Access Compliance Report

Public Rights-of-Way

Intersection ID: 47447	Main Street: ACCIPITER_WY	Cross Street: CHRISTENBURY_RD	Location: W
ADA ID: 45C751EE5AF4	Ramp Type: BlendTrans1	Initial Pass/Fail: Fail	Overall Compliance: No
Severity Score: 21.25			
Codes/Mitigation Info/Possible Solution		Field Measurements/Component Compliance

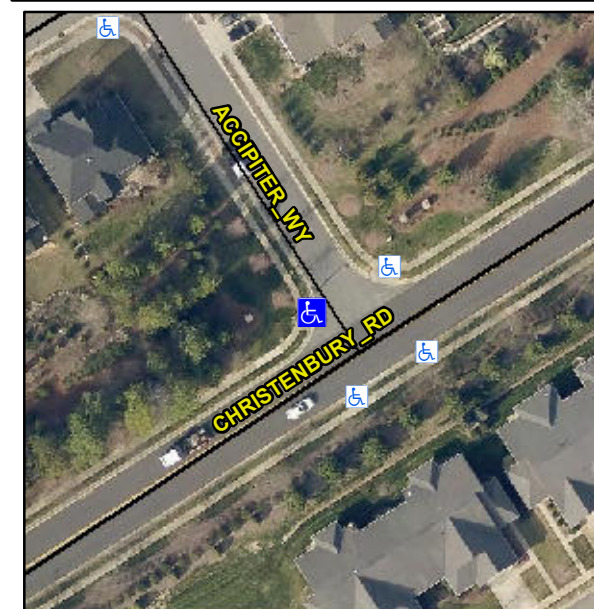
Remove & Replace Curb Ramp With Two New Directional Ramps or Equivalent.

R304.5.1, R304.5.3

Compliance	Description	Data	Compliance	Description	Data
N/A	Ramp Length (in)	48.0	Yes	BlendTrans Slope (%)	4.4
No	Ramp Width (in)	39.5	No	BlendTrans XSlope (%)	5.9
N/A	Flare Type LT	N/A	N/A	Flare Type RT	N/A
N/A	Flare Slope LT (%)	N/A	N/A	Flare Slope RT (%)	N/A
N/A	Flare Traversable LT?	N/A	N/A	Flare Traversable RT?	N/A
N/A	Landing Length (in)	N/A	N/A	DWS Provided?	N/A
N/A	Landing Width (in)	N/A	N/A	DWS Contrast?	N/A
N/A	Landing Slope (%)	N/A	N/A	DWS Length (in)	N/A
N/A	Landing X Slope (%)	N/A	N/A	DWS Full Width?	N/A
N/A	Landing Curb? (Y/N)	N/A	N/A	DWS Offset (in)	N/A
N/A	Shared Landing?	N/A			
N/A	Gutter Ponding?	N/A	N/A	Gutter Slope (%)	N/A
N/A	Gutter Lip Ht (in)	N/A	N/A	Gutter X Slope (%)	N/A
N/A	Painted X Walk1?	No	N/A	Painted X Walk2?	No
	X Walk 1 Direction	To SE		X Walk 2 Direction	To NE
	X Walk 1 Width (in)	N/A		X Walk 2 Width (in)	N/A
	X Walk 1 Slope (%)	3.5		X Walk 2 Slope (%)	1.4
	X Walk 1 X Slope (%)	0.1		X Walk 2 X Slope (%)	5.8
